RESPONSE TO SUBMISSIONS REPORT

Hawkesbury Centre of Excellence - SSD 15001460

10 November 2021

Roof Form Adjustments

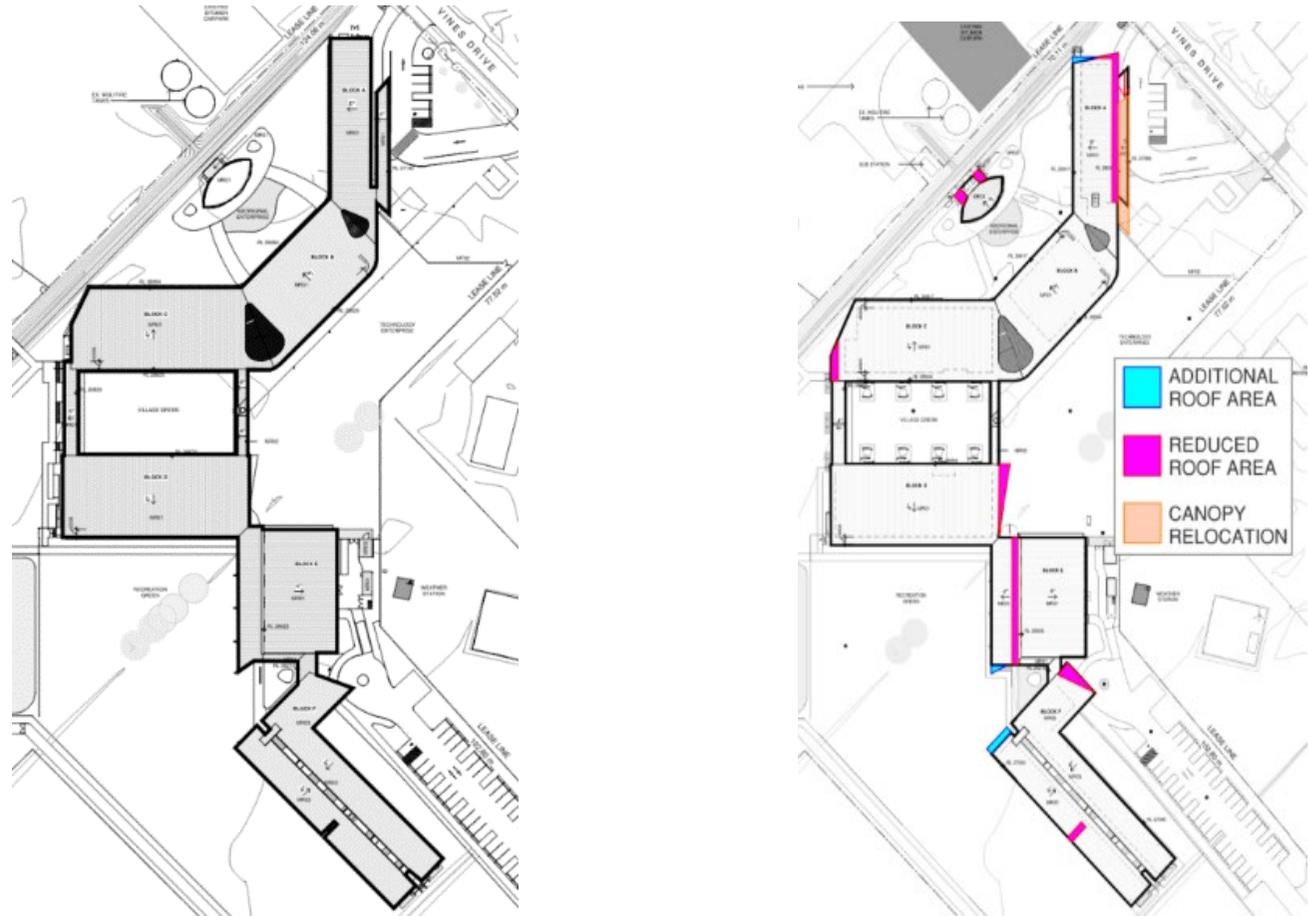
This design rationalisation provides structural design efficiency for a more economical solution. The Main Entry Canopy located on the East of the Administration Block (Building A) has been shifted further south to provide covered Public Entry. The figure below highlights the extent of additions and reductions of roof area.

Reduction in Glazed Areas

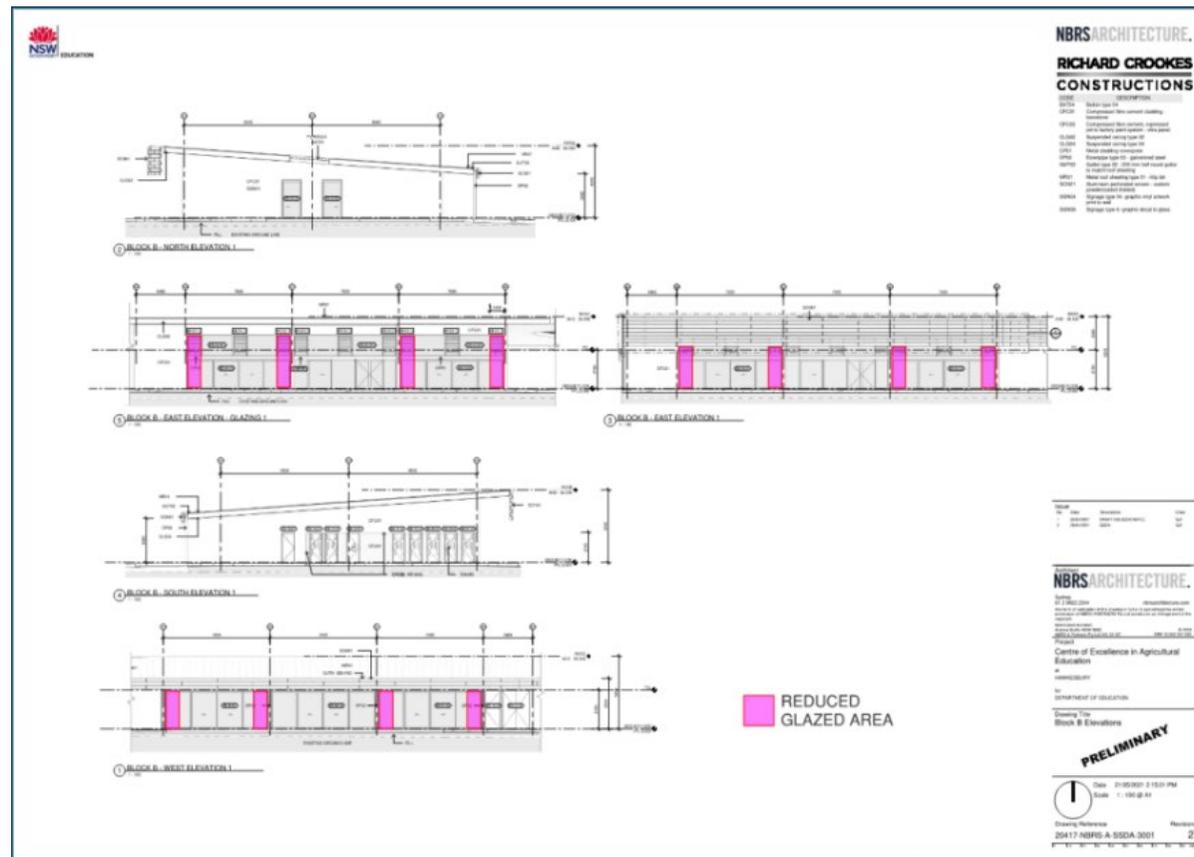
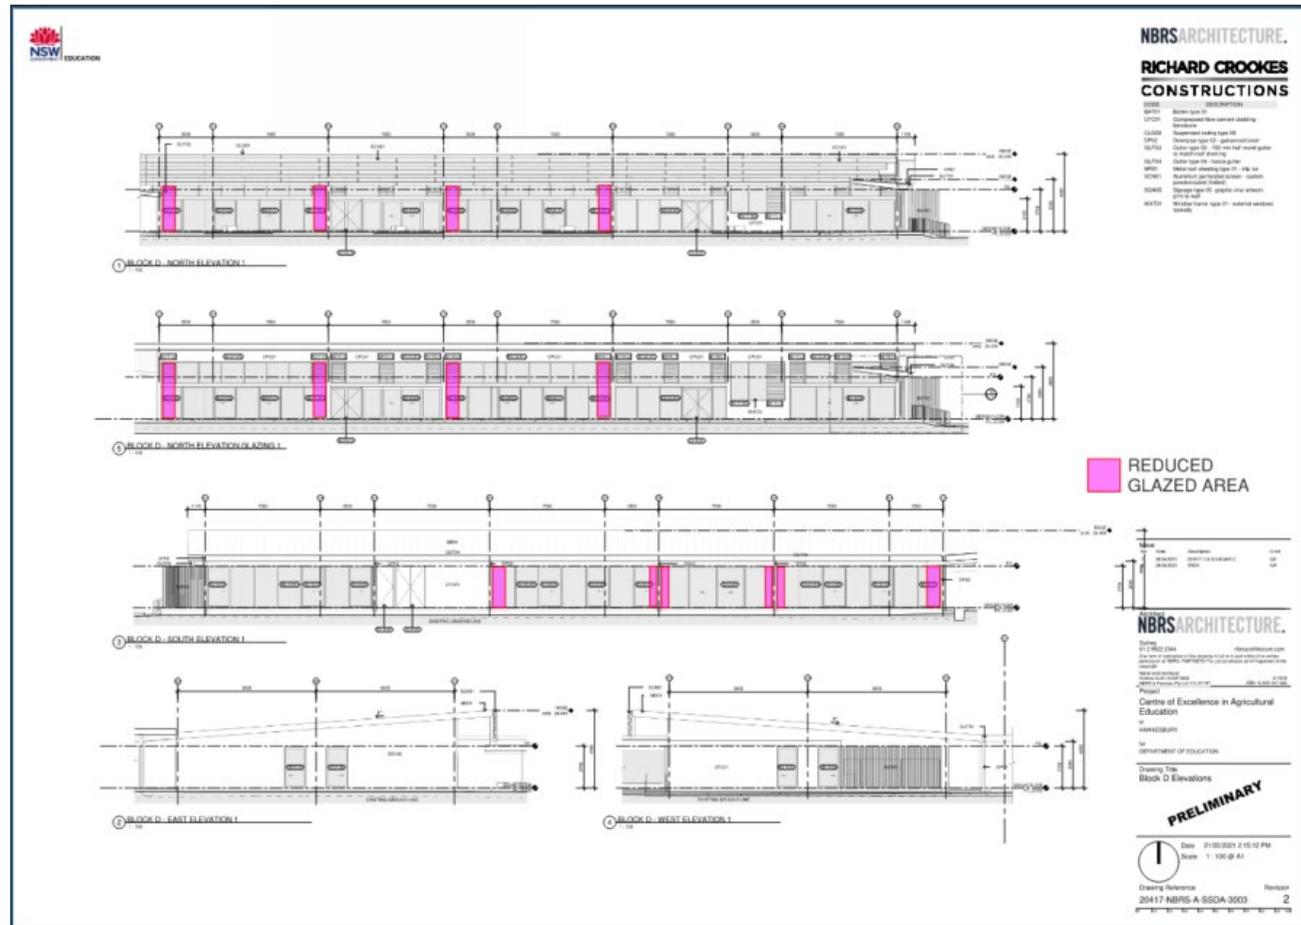
Building B

Building C

Building D

Accommodation Block, Building E

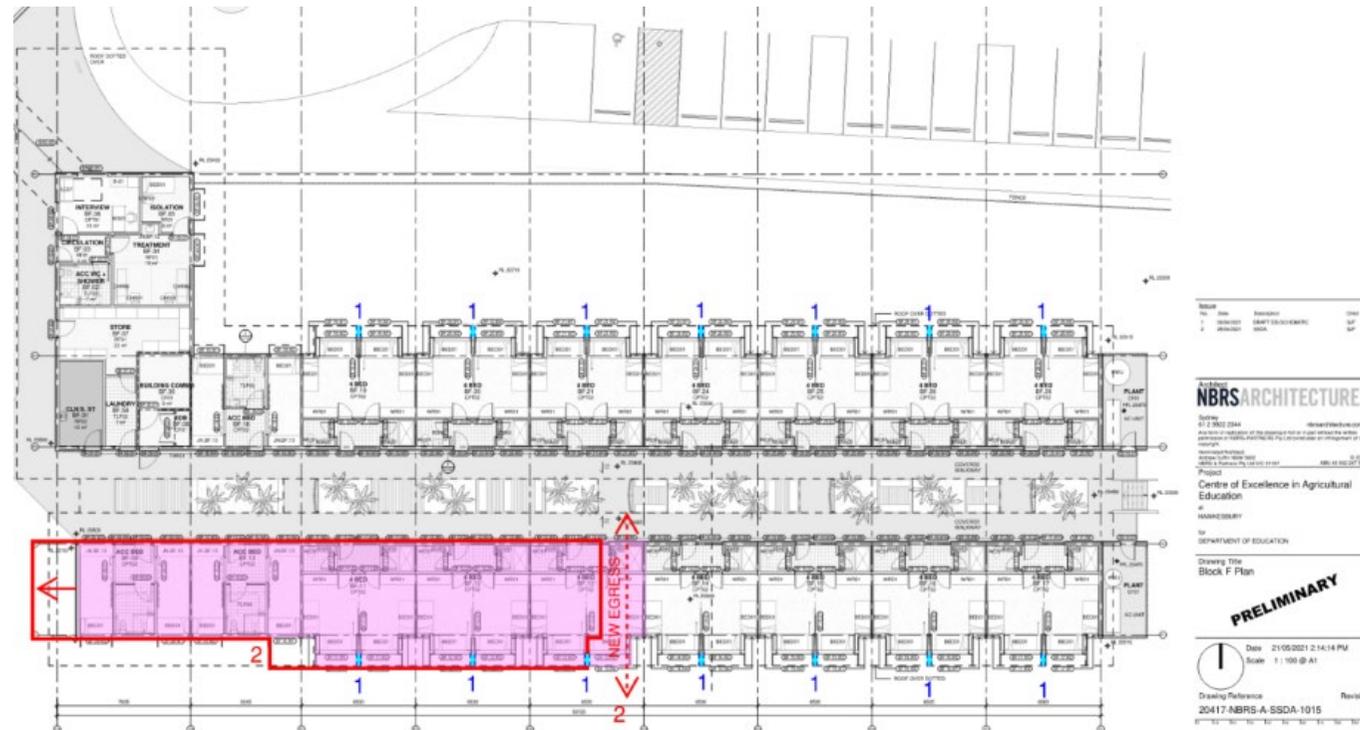
Design change 1 – Removal of external protrusion of the recessed retractable doors as highlighted in light blue on the drawing to the right.

Design change 2 – Create an additional egress at mid-point of the southern portion of the Accommodation Block as highlighted in red lines & hatch on the drawing to the right.

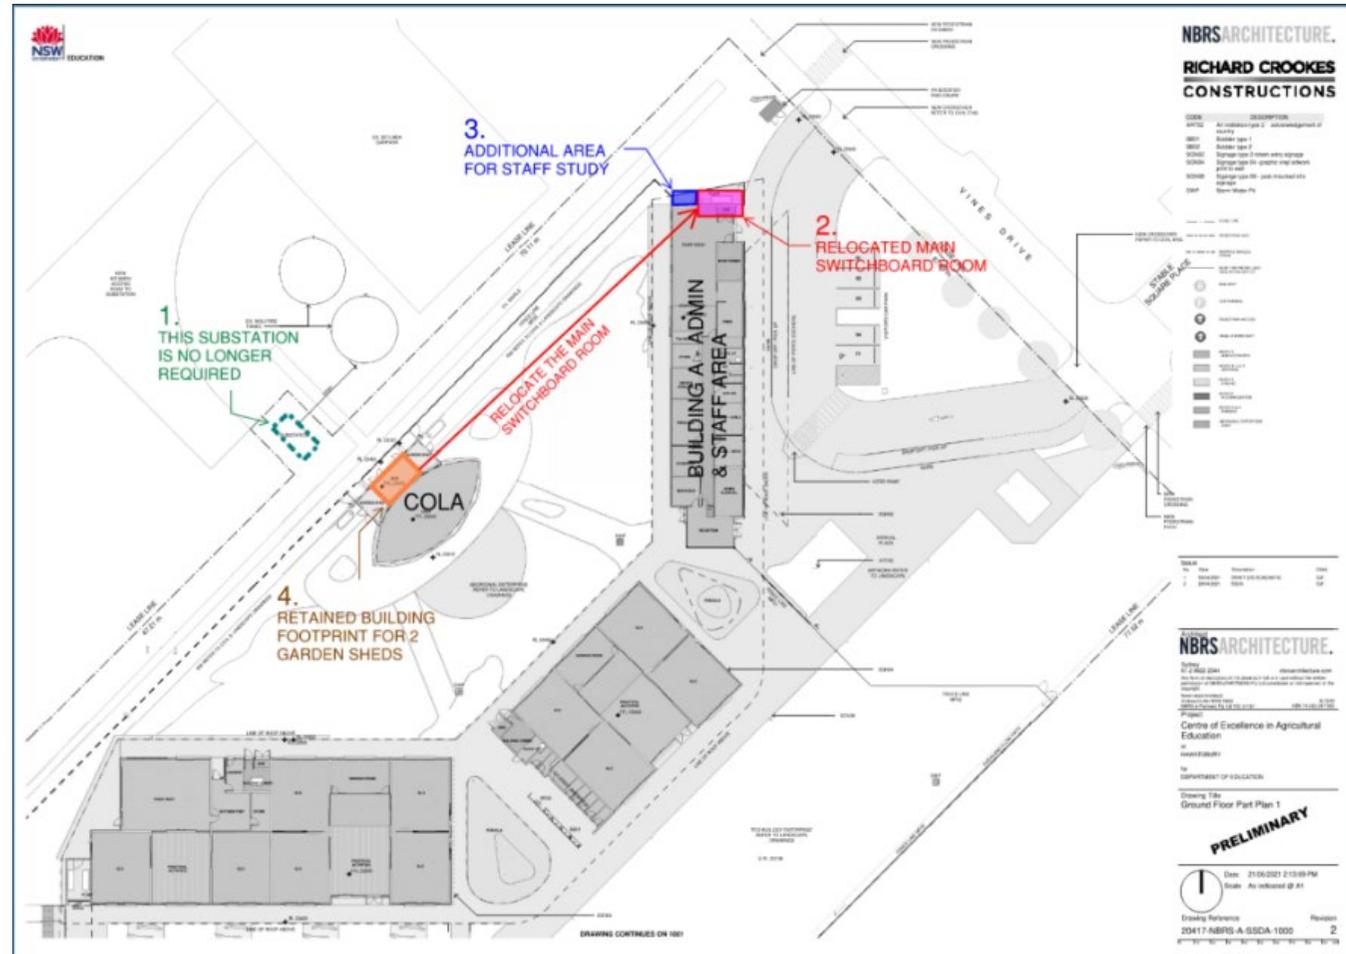
1. The proposed new substation for sole use by COE is no longer required
2. Relocation of COE's Main Switchboard Room to the northern end of Building A to be closer to the existing WSU's Substation.
3. A small additional area has been created for the Staff Study to compensate the loss of usable area as a result of the relocation of the main switchboard room.

the entry to the proposed Centre of Excellence. 4. A smaller building area as highlighted in orange on the following drawing represents the remaining building footprint suitable for two garden sheds.

BUILDING C Footprint Reduction:

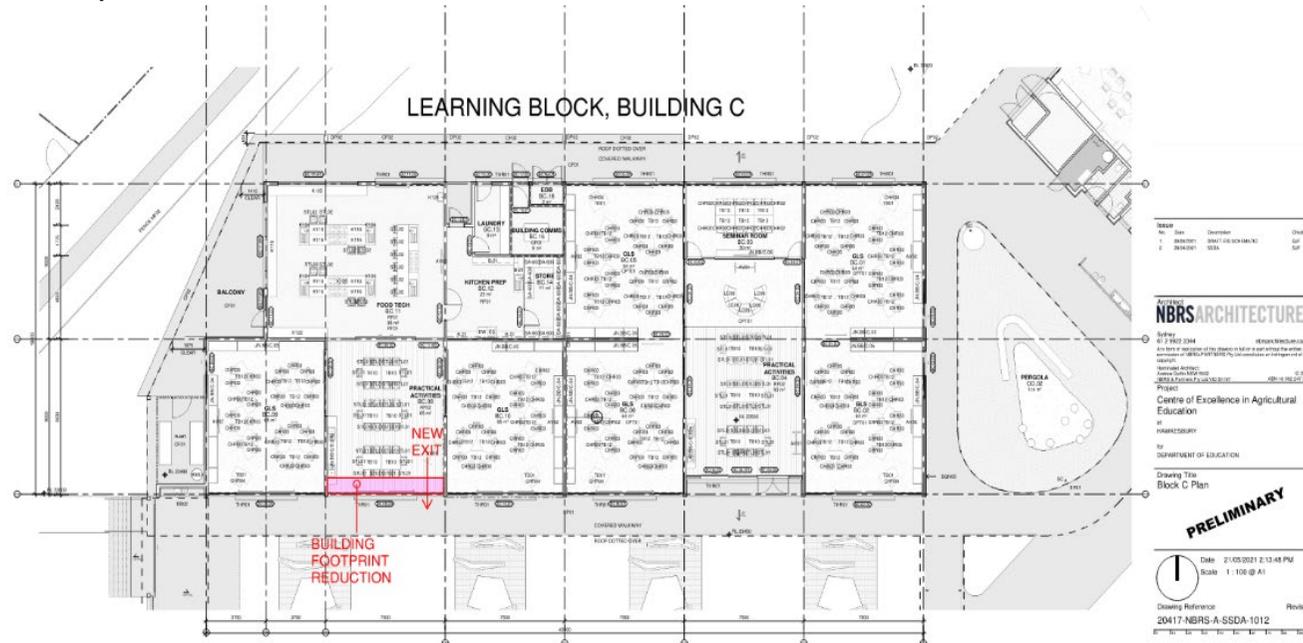
Minor Building Footprint Reduction – Building C & D

1. The inclusion of an additional recessed section of the southern façade alters the southern elevations of building C and D.
2. The functionality of the science area in Building D will significantly improve by flipping the Botany/ Zoology with the neighbouring Practical Activity Area. This provides the opportunity for better daylight harvesting & ventilation into the Botany and Zoology facilities.

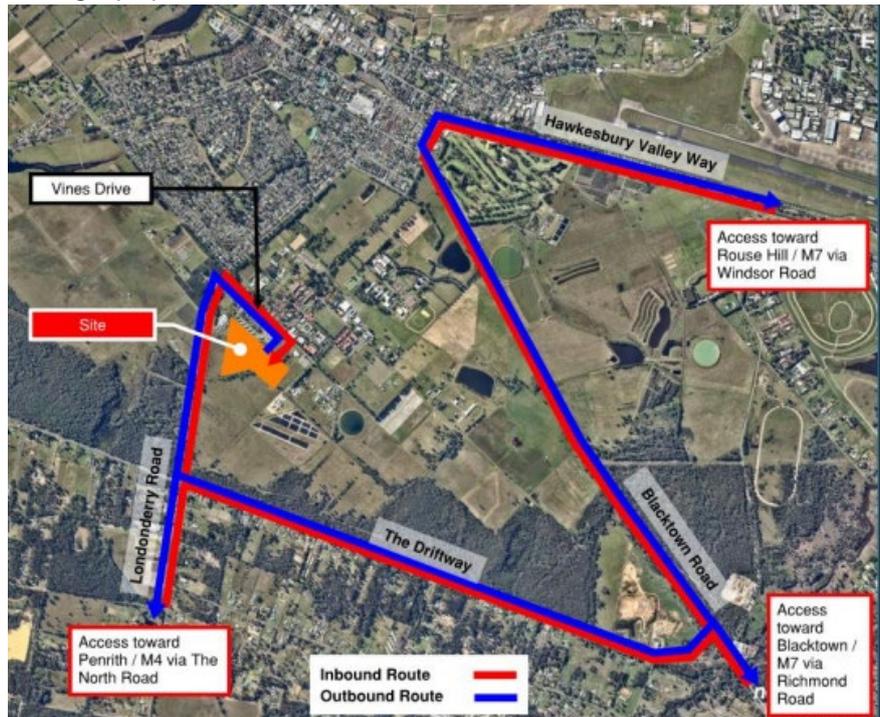
additional short-route public bus services between the Richmond Station and the proposed school are required to accommodate the patronage, bus services should be terminated at the stop located as close as possible to the school entrance. This will significantly reduce the pedestrian demand crossing Londonderry Road. A bus turnaround facility should be provided on Vines Drive, as the result of the need of additional short-route bus services specifically for the proposed development.

Refer to Section 3.6 – *Bus Zones*, 3.7 – *Pick-up and Drop-off* and 3.0 *Infrastructure and Safety Improvements* of the TAIA under **Appendix B**.
